Title: HX SBA Frame Tie Relocation**Applies To:** HX Series (SBA); Applies ONLY to listed (30) VIN's within this IK Document

Some HX series will require the frame tie bracket to be relocated, see VIN list.

Figure 2: Frame Tie Relocation**CAUTION:**

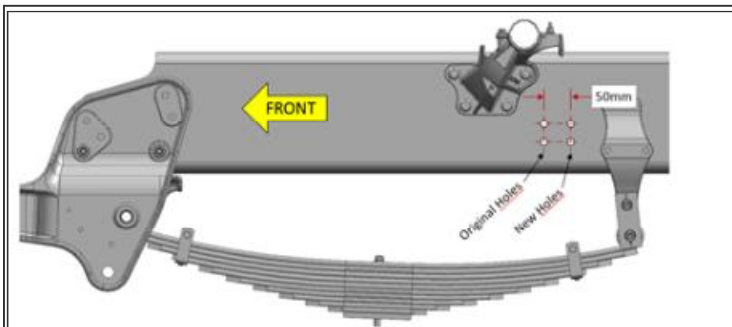
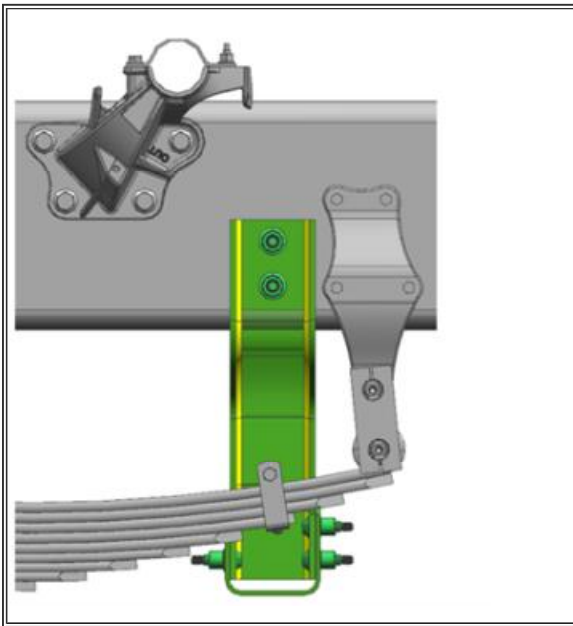
- 1) Install rear wheel chocks, open hood and turn the wheel to access the frame tie bracket.
- 2) Support the frame tie bracket assembly and remove (2) huck/collars.
- 3) Measure and mark the frame from the center line of the original bolt hole 50 mm rearward.

- 4) Drill both sides of the frame using a 13/16" bit.
- 5) Position and install frame tie bracket assembly with new hardware and torque: 368-461 ft/lbs (500-625 N/m).
